Tech Note 091 Ford CSC Design & Bell Housing Clearance

Ref: TN91 Issue Date: April 2016 Issue Number: 01

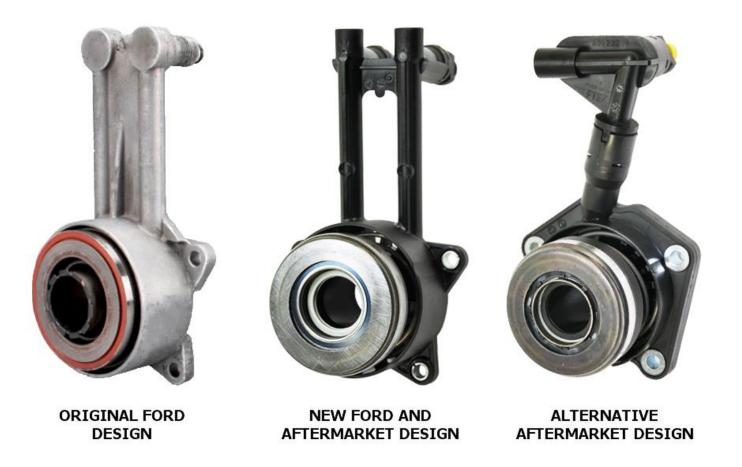
The replacement Concentric Slave Cylinder (CSC) may be visually different from the original Ford CSC removed from the vehicle (as seen below). Despite this visual difference the functional operation of the new and original CSC are the same.
